**MONTGOMERY COUNTY HISTORIC PRESERVATION COMMISSION**  
**STAFF REPORT**

<b>Address:</b>	6124 MacArthur Boulevard, Bethesda	<b>Meeting Date:</b>	4/12/2023
<b>Resource:</b>	Master Plan Site #35/47 ( <i>Bonfield's Garage</i> )	<b>Report Date:</b>	4/5/2023
<b>Applicant:</b>	Silber Fuchs LLC	<b>Public Notice:</b>	3/29/2023
		<b>Tax Credit:</b>	N/A
<b>Review:</b>	HAWP	<b>Staff:</b>	Rebecca Ballo Michael Kyne
<b>Case Number:</b>	897899 REVISION

**PROPOSAL:** Alterations to previously approved HAWP for new lighting and security cameras, screening, and building alterations.

Response Submission Regarding Modifications to the Approved HAWP

Fig. 2: Proposed lighting fixture locations circled in red.

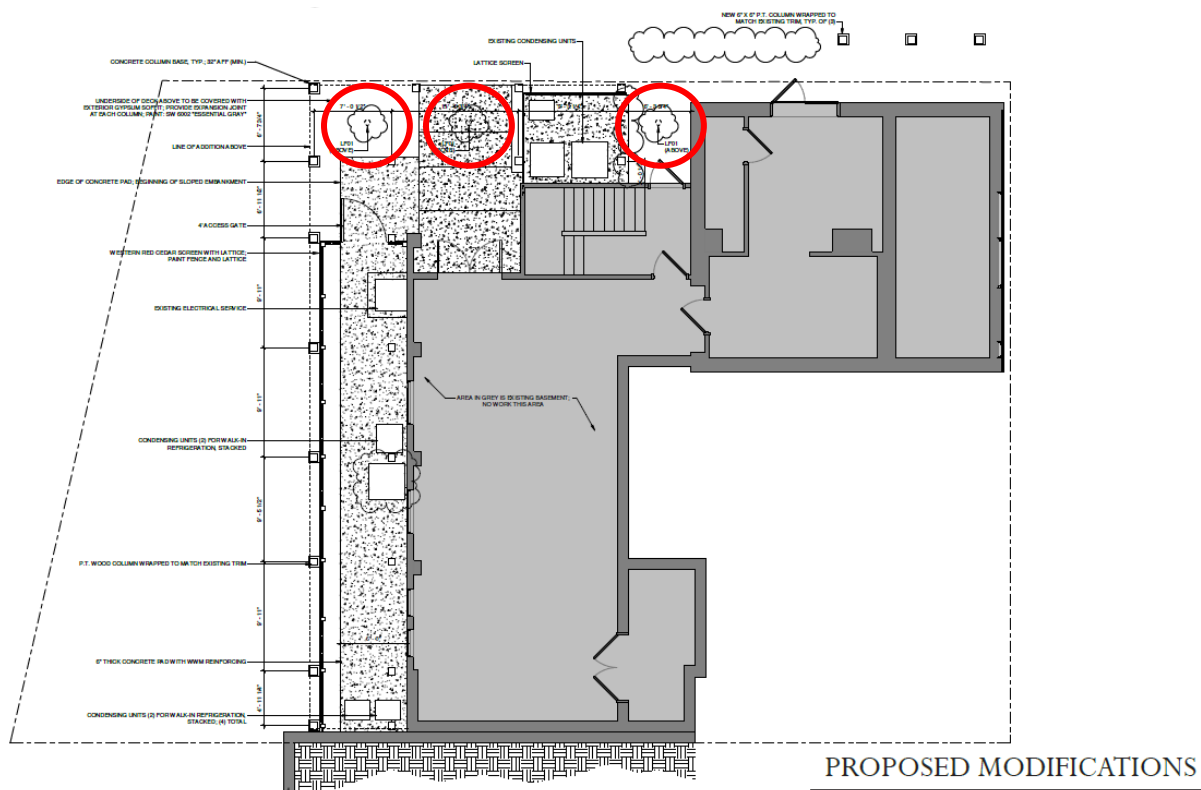
- The installation of three light fixtures under the deck at the right side of the building. The proposed lights fixtures will be recessed, so that they are not readily visible from the public right-of-way. Additionally, the lighting will be LED, each with lumens equivalent to a traditional 75-watt incandescent light bulb, and warm color temperature (2700 Kelvin, see Fig. 3).

Fig. 5: Previously approved plan, with screening door circled in red.

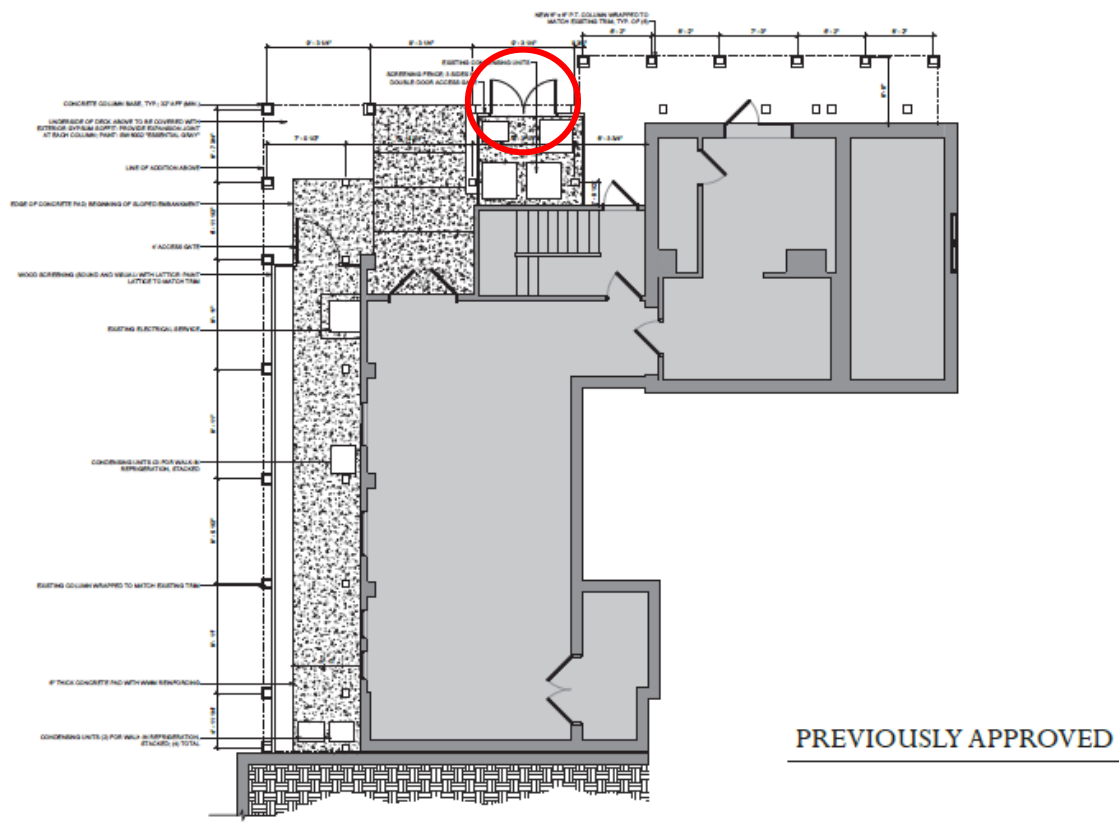
- The applicant previously proposed to install one additional condensing unit at the right side of the building, which was to be enclosed by a sound barrier with lattice screening. However, the applicant learned that the sound barrier in this location would not allow sufficient air circulation for the condensing units. As a result, the additional condensing unit will be moved to the rear of the building within the existing sound barrier/screening, where there is sufficient space. The applicant does propose to retain two sides of the lattice screening at the right side of the building to provide some visual screening of the three existing units (confirmed by staff's site visit photographs, see *Fig. 4*). Staff also notes that the previously approved access door at the right side of this screening (*Fig. 5*) has been removed from the proposal, as it was determined that the door would open into the public right-of-way. Access will now be provided via the open side of the screen.

1 FLOOR PLAN - LOWER LEVEL  
10/11/19

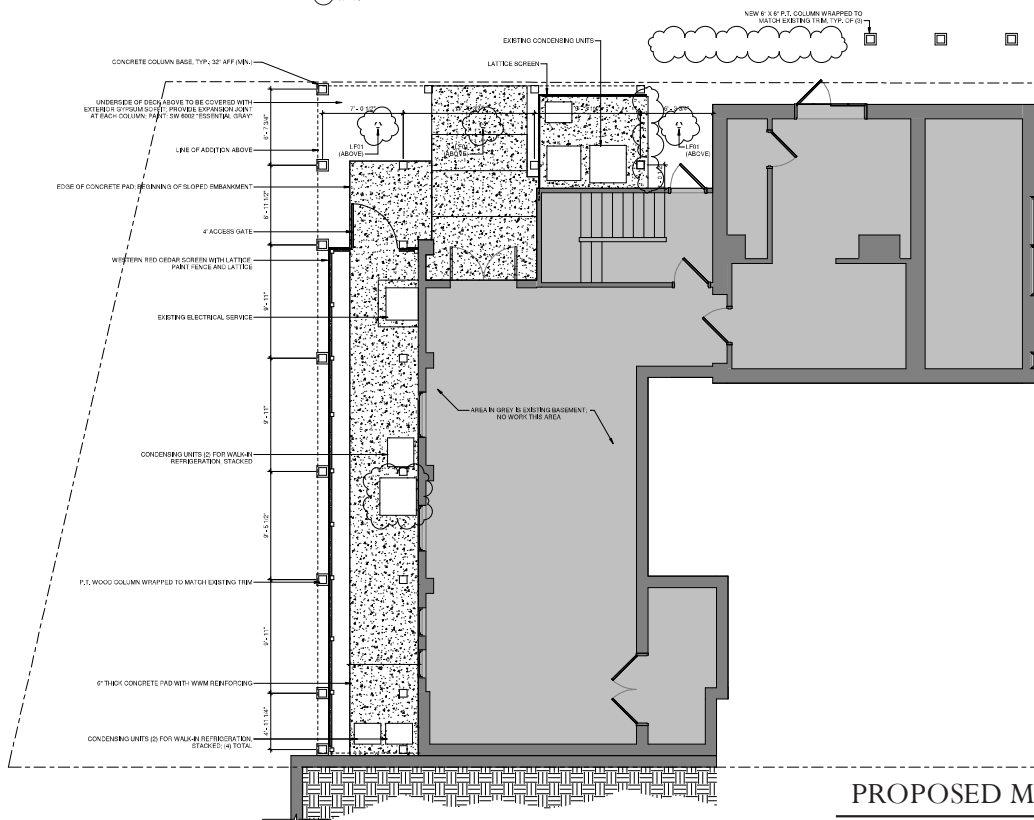
- Eliminated three columns in ROW, per MCDPS
- Relocated condensing unit behind sound screen and adjusted visual screen accordingly
- Added three recessed downlights at exterior door locations (LED, 75 W equivalent, 2700 K); cutsheet included in complete submission
